**10A Oakhill Avenue
London, NW3 7RE**

**Basement Impact Assessment
Audit**

Project Number: 12066-40
Revision: F1

January 2016

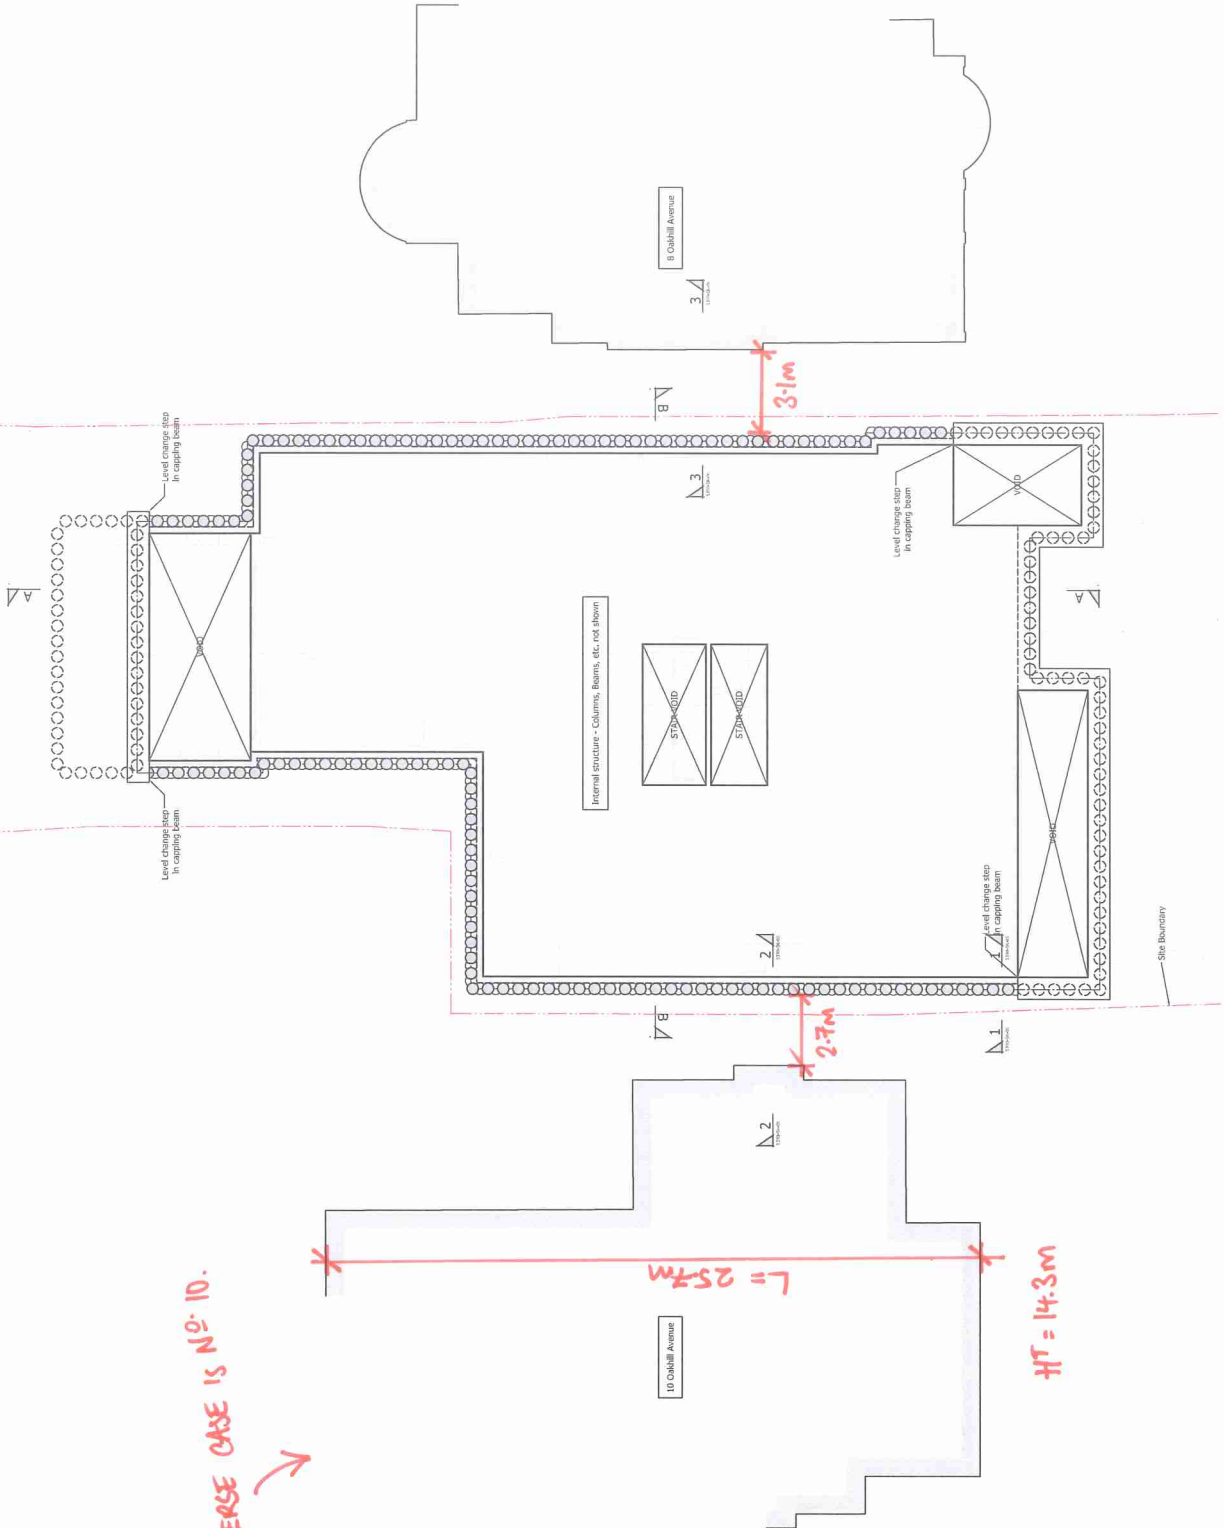
Determine the effect on structures within the zone of influence.

- The following sketch (5390-SK-02) shows a site plan.
- No. 10 Oakhill is considered the adverse case within the zone of influence.
 - The property is a masonry structure.
 - The distance from the piled wall is 2.7m
 - The length of the property is 25.7m
 - The height of the property is 14.3m
- No. 8 Oakhill is also within the zone of influence.
 - The property is a masonry structure.
 - Distance from the piled wall is 3.1m
 - The length of the property is 23.8m
 - The height of the property is 14.0m

ADVERSE CASE IS NO. 10.
